Product Change Notification

Overview: Please be advised that the following is notice of change to Fire Research TankVision pressure sensors.

Products Affected: Tank pressure sensors used for the TankVision indicator. This includes the following FRC part numbers:
XE-WLPT1-Sxx (0 – 5 psi), XE-WLPT10-Sxx (0 – 15 psi)

Fire Research Corp.
Drawing Number
XE-XXWLPT3DWG.R0A
Date 09NOV10

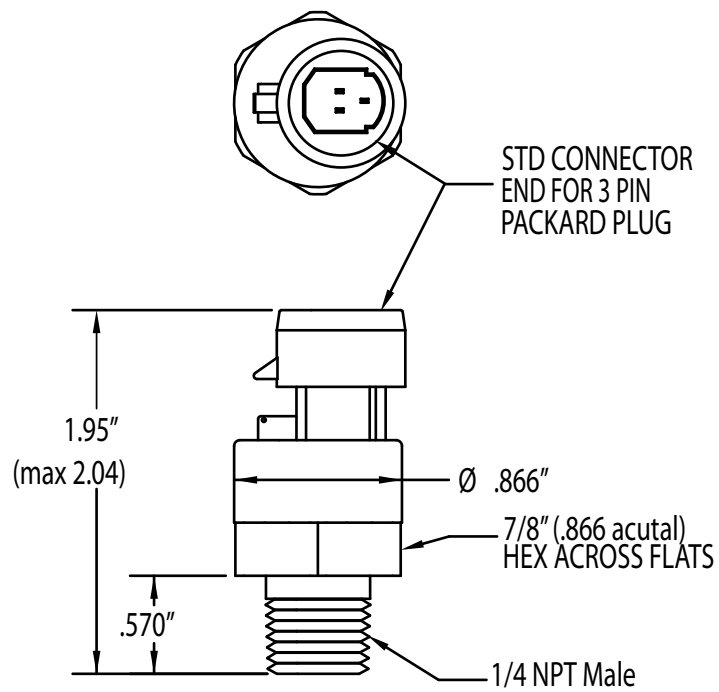
Change Description: The above pressure sensors are being discontinued. New PT3 series pressure sensors will be direct replacements in all orders starting on or about 01NOV10

Important Note: The new PT3 series sensors are slightly smaller than the PT1 series (smaller by 1 inch in height and 0.75 inch in width). Refer to the referenced drawing for complete dimensions of the new sensors.

Replacement Product: New pressure sensors will be direct replacements. They meet or exceed all electrical and mechanical requirements, use the same 3-Pin Packard connector, and mount in the same size 1/4 inch NPT port.

The following are FRC part numbers for the new sensors:
XE-WLPT3-S0A (0 – 5 psi), XE-WLPT30-S0A (0 – 15 psi)
